## SUBDIVISION REVIEW SHEET

**CASE NO.:** C8-2016-0042.0A**P.C. DATE:** April 11, 2017**SUBDIVISION NAME:** Resubdivision of Lot 3C: Amended Plat of Lots 3A, 3B & 3C,  
Bunche Road Subdivision**AREA:** 0.906 acres**LOT(S):** 3**OWNER/APPLICANT:** Bodhi Group, LLC  
(Yusof Johnson)**AGENT:** Land Answers, Inc.  
(Jim Wittliff)**ADDRESS OF SUBDIVISION:** 1809 Webberville Rd.**GRIDS:** M23**COUNTY:** Travis**WATERSHED:** Fort Branch**JURISDICTION:** Full**EXISTING ZONING:** MF-3-NP**NEIGHBORHOOD PLAN:** M.L.K. – 183 / East M.L.K. Combined**PROPOSED LAND USE:** Single-Family

## MEMORANDUM

**SUBJECT:** C8-2016-0042.0A Resubdivision of Lot 3C: Amended Plat of Lots 3A, 3B & 3C, Bunche Road Subdivision

## RESUBDIVISION OF LOT 3C: AMENDED PLAT OF: LOTS 3A, 3B & 3C, BUNCHE ROAD SUBDIVISION

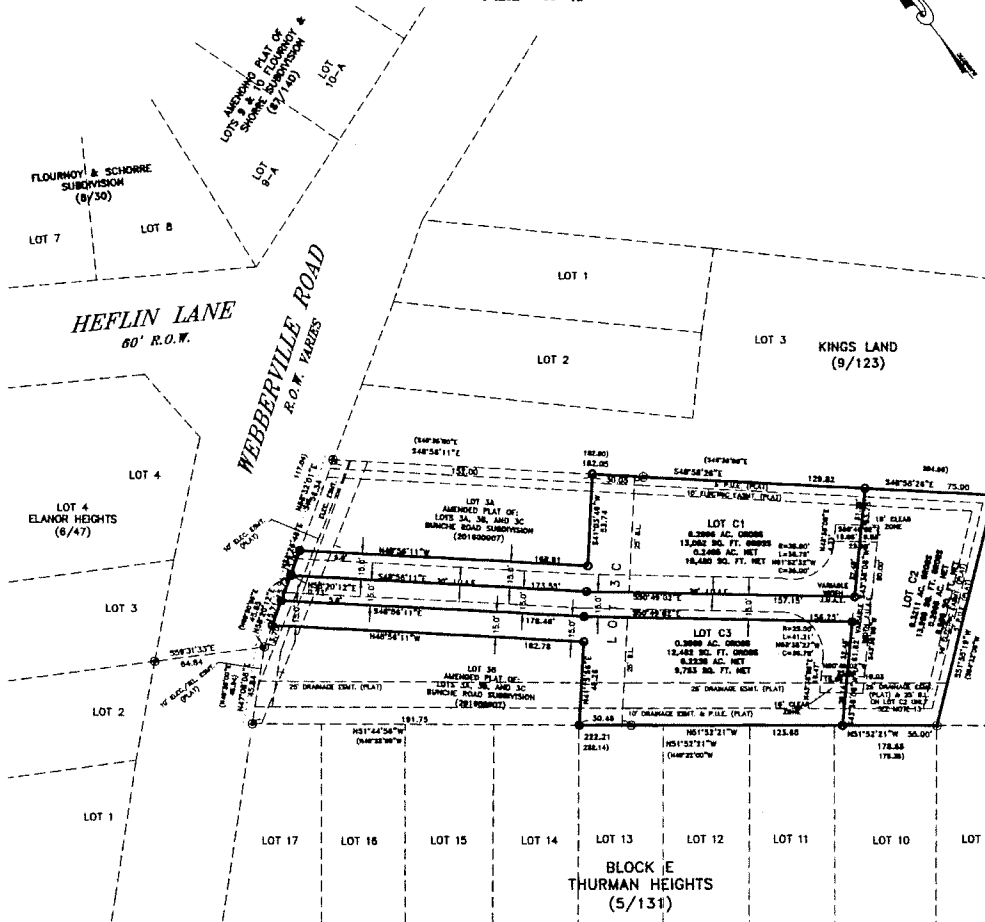
The applicant for the above referenced subdivision application has requested a variance from Section 25-4-175(A)(2) of the Land Development Code to utilize a flag lot design for a resubdivision creating three residential lots. In reviewing the variance request, staff evaluated the request based upon the criteria below, (see criteria and staff response):

*The applicant has met with Austin Fire Department review staff and AFD staff has determined that the flag lot configuration proposed will not inhibit accessibility for emergency responders.*

*The applicant has provided a driveway and utility plan to reviewers for the City of Austin Water and Wastewater review and Austin Energy Departments. The reviewers have determined after review of the utility/driveway plan that there is adequate room to provide utility service to both lots and utilities will not cross the proposed new lot lines.*

*The applicant has provided a tree survey to arborist staff with the City of Austin and the arborist have no objections or further recommendations.*

*The existing lot is a flag lot and other lots fronting Webberville Rd. have been subdivided using the flag lot configuration. The neighboring lot to the north of this property at 1813 Webberville Rd. has been subdivided as a flag lot. Additionally, the block to the west of this property has a flag lot at 5213 Robb Scott St.*

Based upon review of these criteria, staff **recommends** the variance request to develop a flag lot as a part of this resubdivision request.
